#### Thursday, March 24, 2022

# **Certificates of Appropriateness**

### Case 22-004: Rockefeller Park (Concept Plan 1/13/22) Jesse Owens Olympic Oak Plaza Martin Luther King, Jr. Drive Landscaping and Site Improvements Ward 7: Howse Project Representatives: Elise Yablonsky, University Circle, Inc.; Jayme Schwartzberg, DERU Landscape Architecture; Angelica Pozo, Artist

# **Case 22-023:** Ohio City Historic District (Concept Plan 2/10/22) **Wells Residence 4612 Clinton Avenue**

# WELLS RESIDENCE

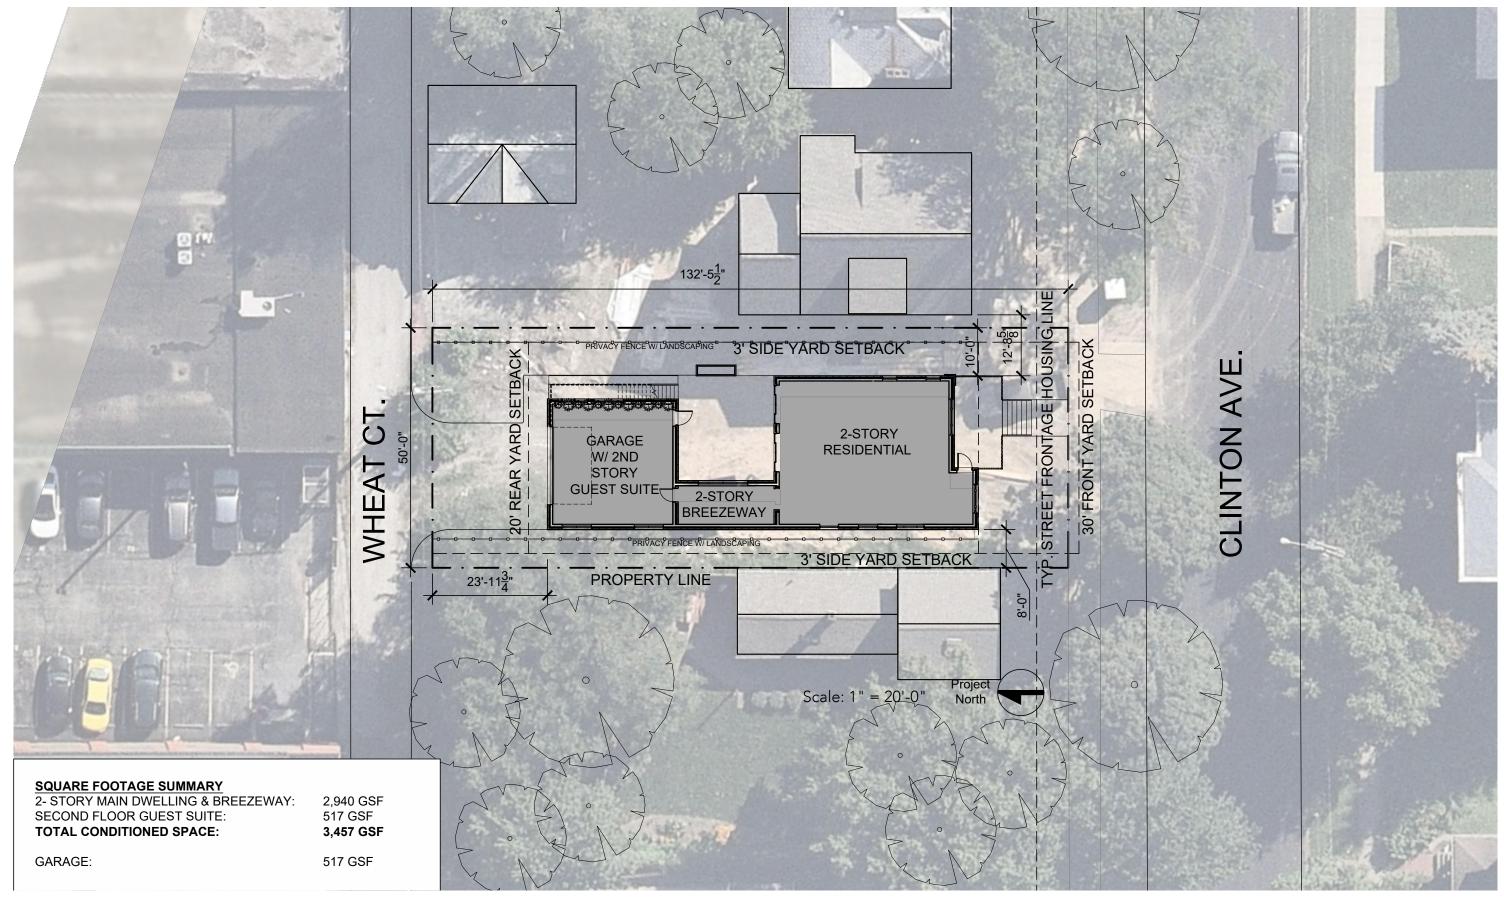
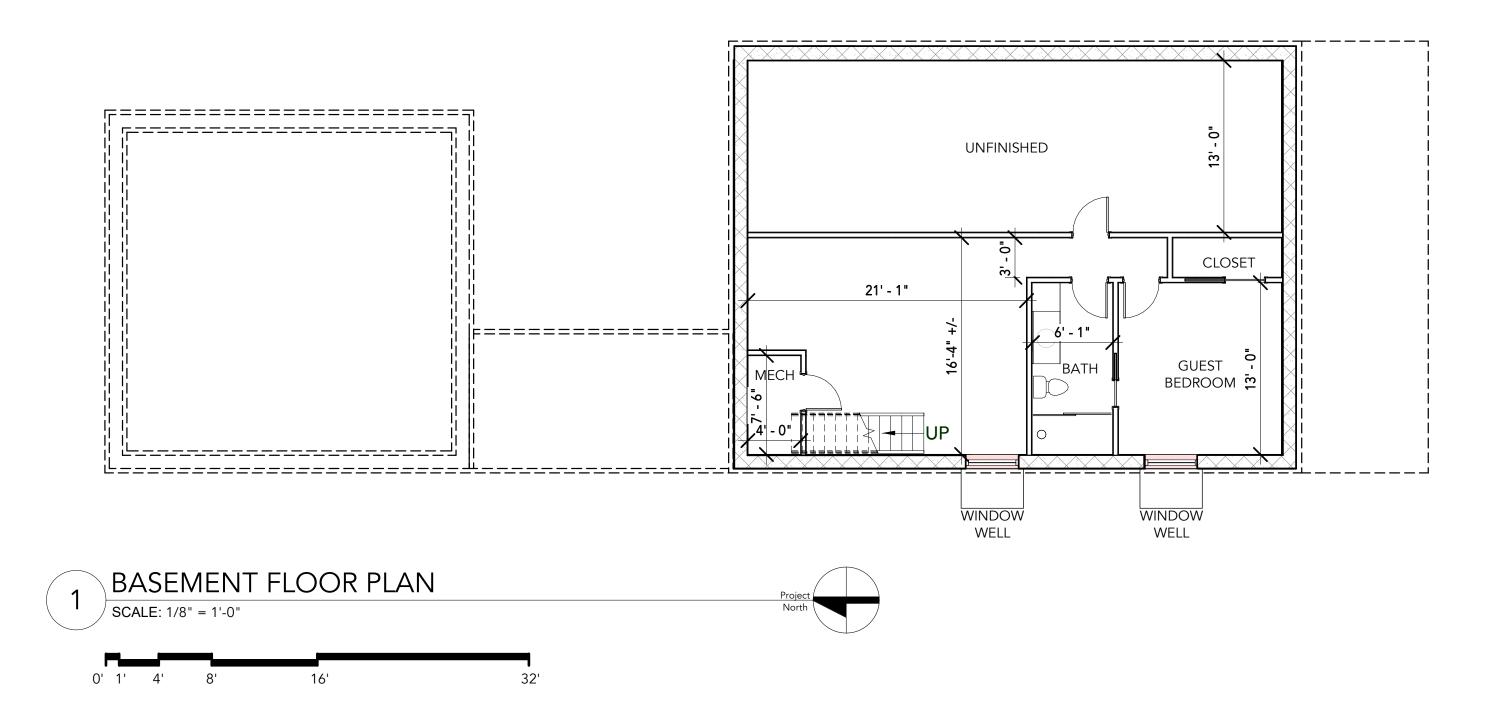
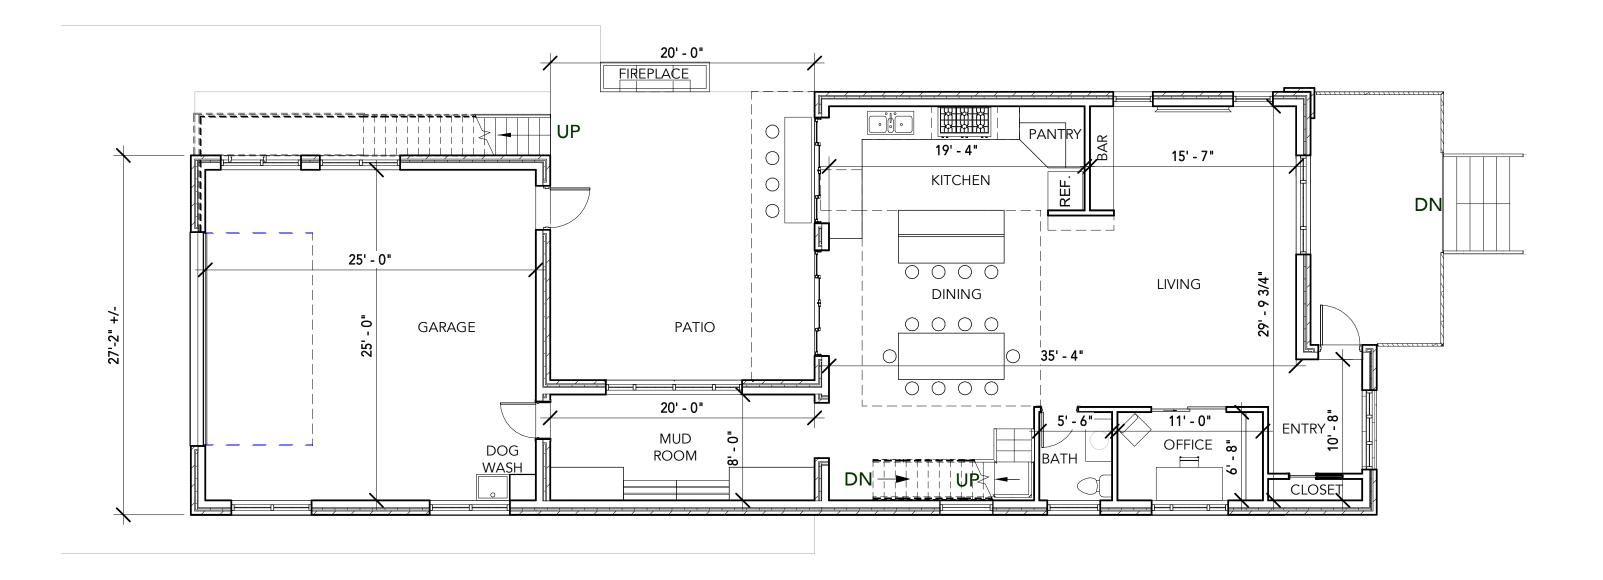
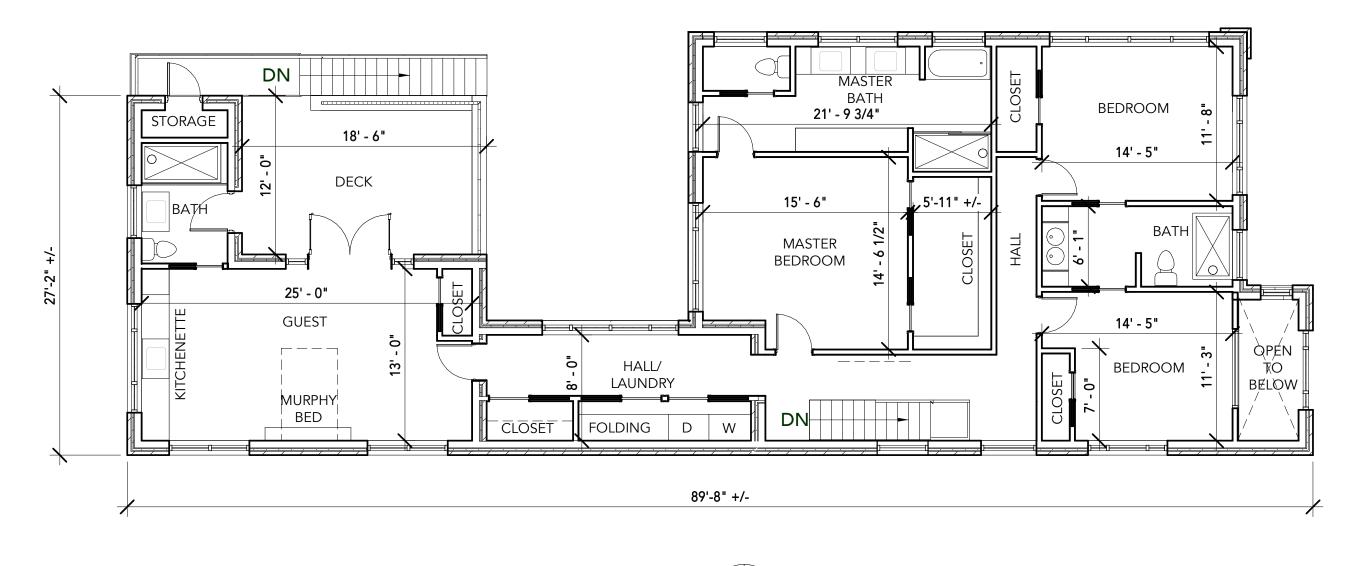
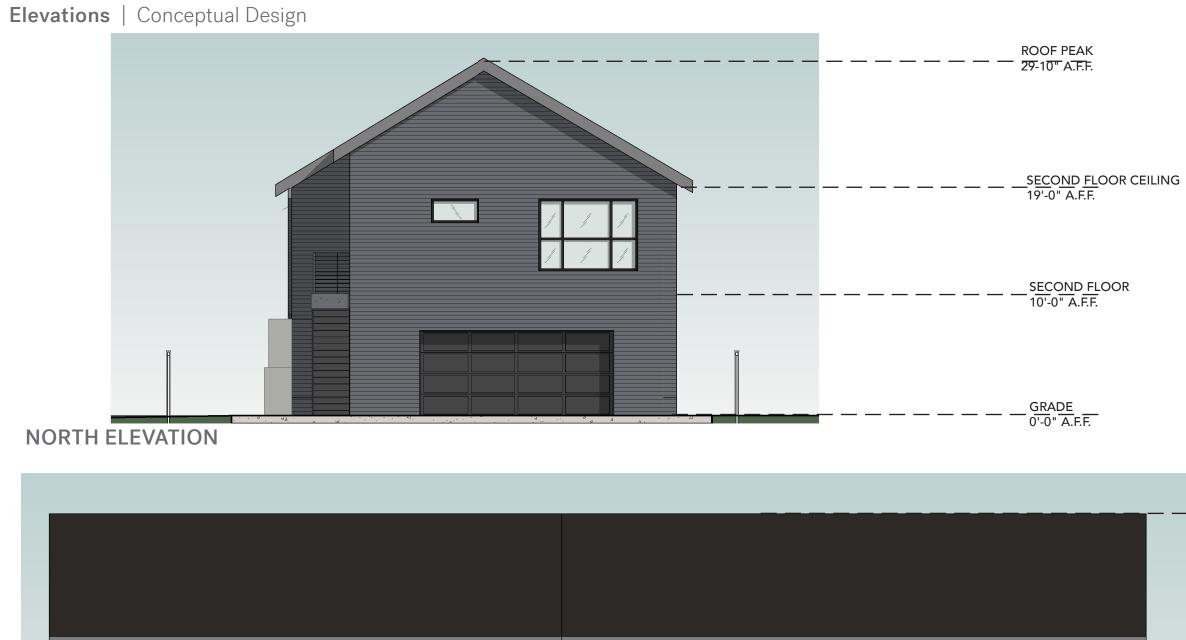
No quorum, no vote taken. Seen two times previous.

Margaret Lann, Marika Clark, Antonia Marinucci all present. Three present committee members agreed that if

roof pitch was heightened, garage door and staircase color darkened, they would recommend approval.

MC & ML appreciated the simplification of window choices and materials. ML stated that the grey brick

material on foundation & darker mortar matches better than previous iteration of project.

AF & CL were not at meeting but provided written feedback, stating that the window style and roof pitch were still not acceptable and needed to be addressed.

Owner unwilling to concede on grey brick color or windows as is. Applicant has previously made significant changes to the project based on design review feedback.
